Supplement

Title:	566/568 Users	Supplement Issue:	1
Print Date:	August 2007	Issue Date:	11/07
Revision/Date:		Page Count:	4

Change #1

Figure 5. Distance and Spot Size

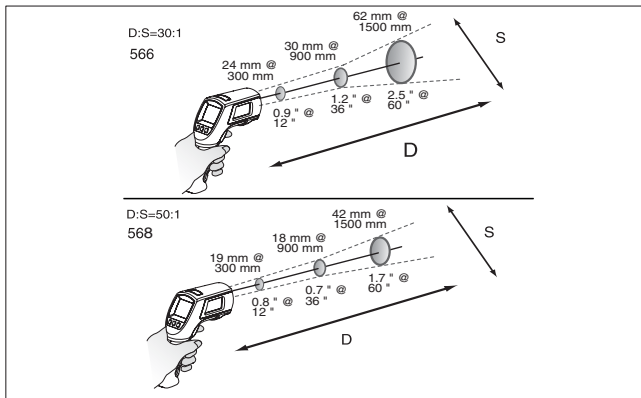
On Page 13, replace Figure 5 with the following:
